RibEye for WorldSID 50th

Original WorldSID RibEYE, Model 8700

New WorldSID RibEye, Model 10000

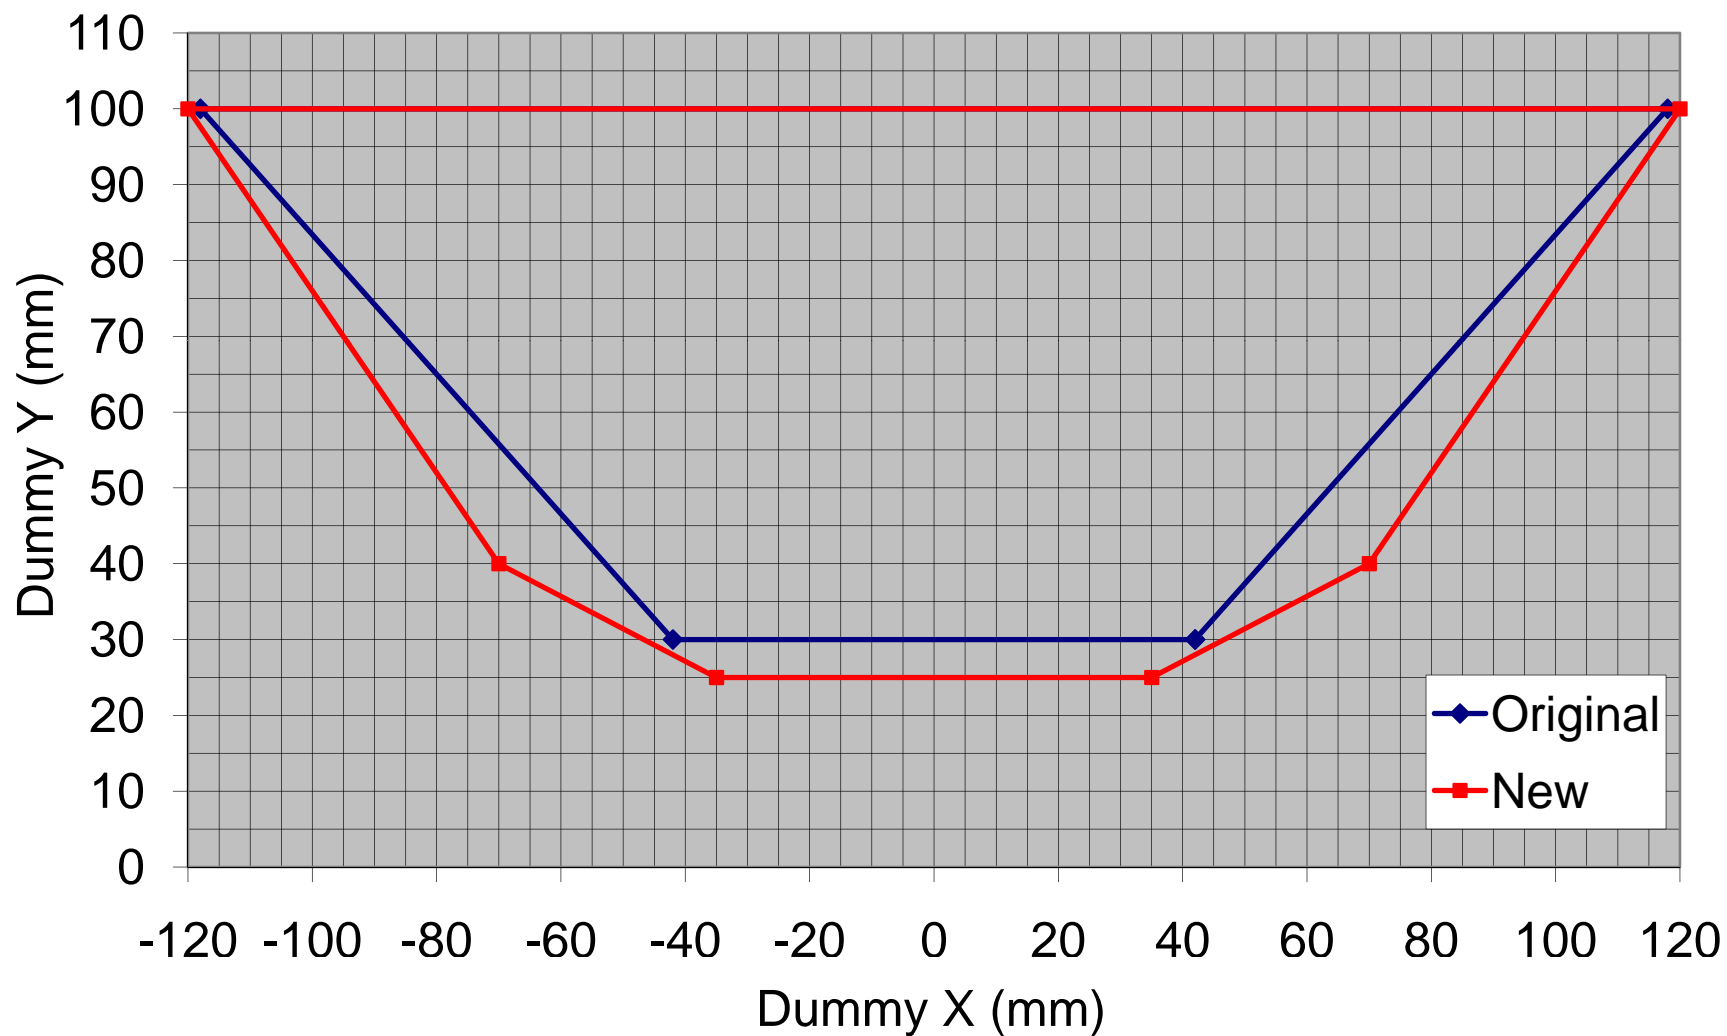
Issues:

- Insufficient measurement range
- Middle rib on each set can block upper and lower ribs on the set
- Sensor connectors damaged during testing
- Lenses moved causing errors
- Firmware bugs

- Increased range
 - LED and sensor angles optimized
 - LEDs relocated on rib mounting blocks
 - Mounting block thickness minimized
 - Updated electronics with improved LED current control
- Improved durability:
 - Sensor connectors relocated on controller
 - Sensor lenses bonded in position
- Firmware improvements

Sensor input connector damage

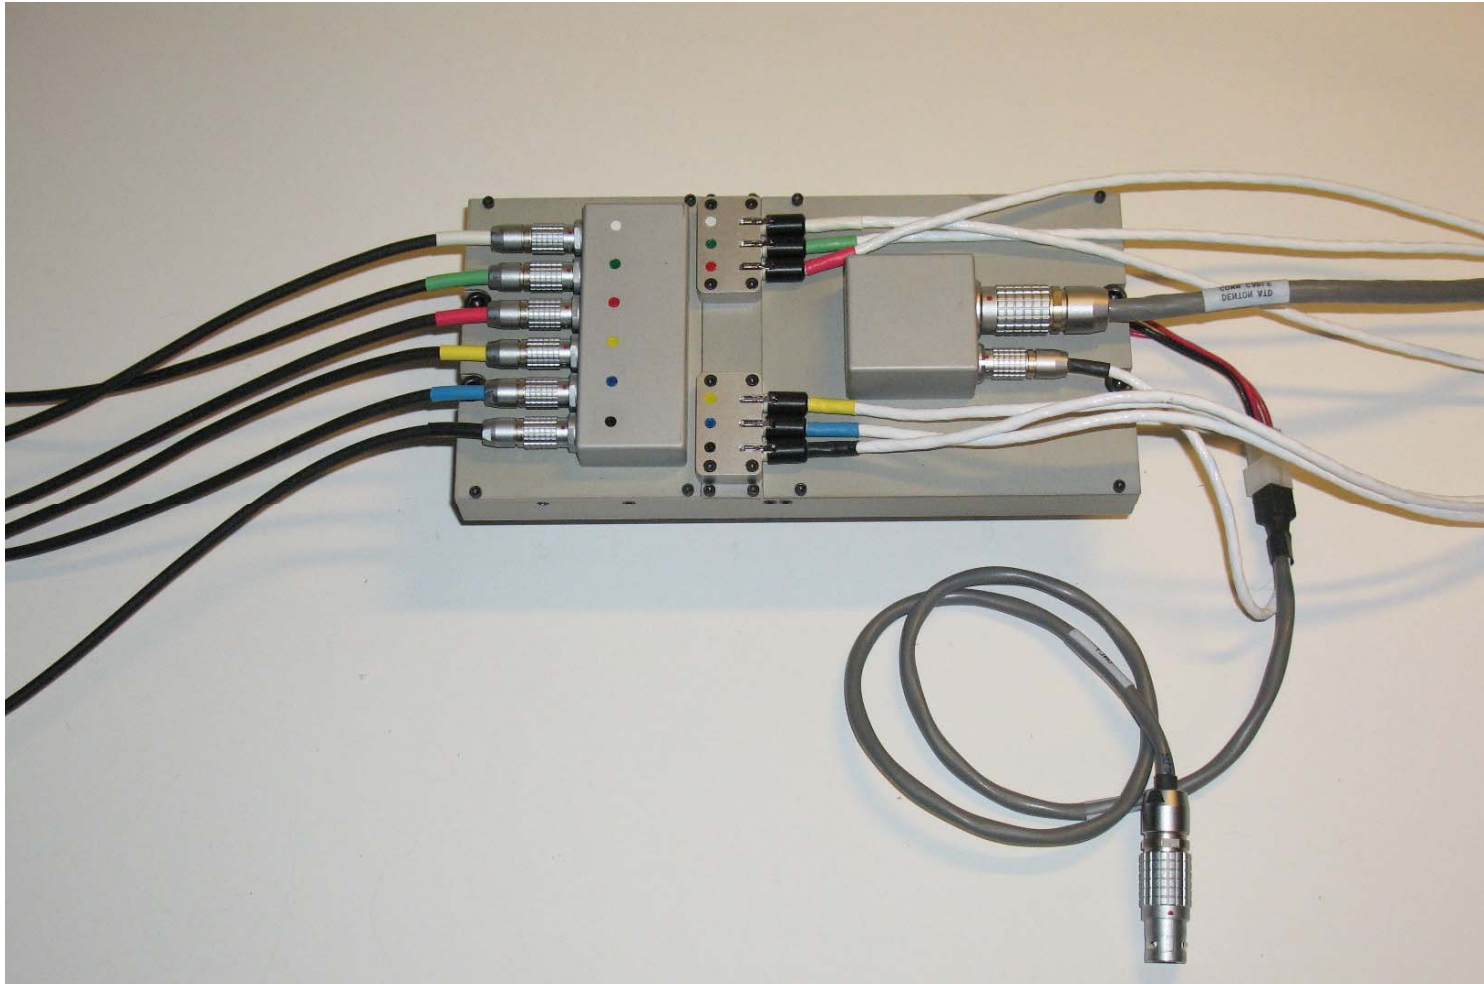
Bottom of thorax, non-struck side

Control enclosure with connectors installed

Model 8700 Middle Rib (Thorax 1 and Abdominal 1) Interference

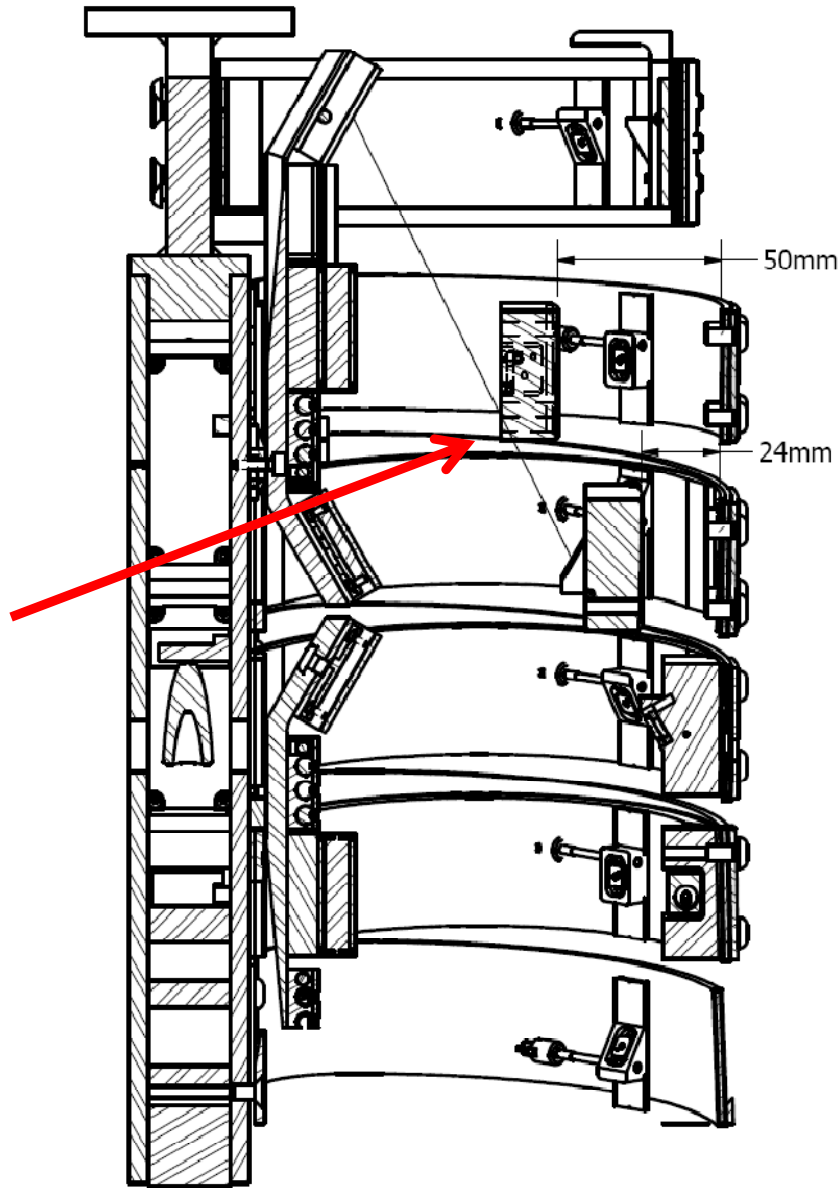
Middle Rib
LED can
block light
path

Improved LED Housings
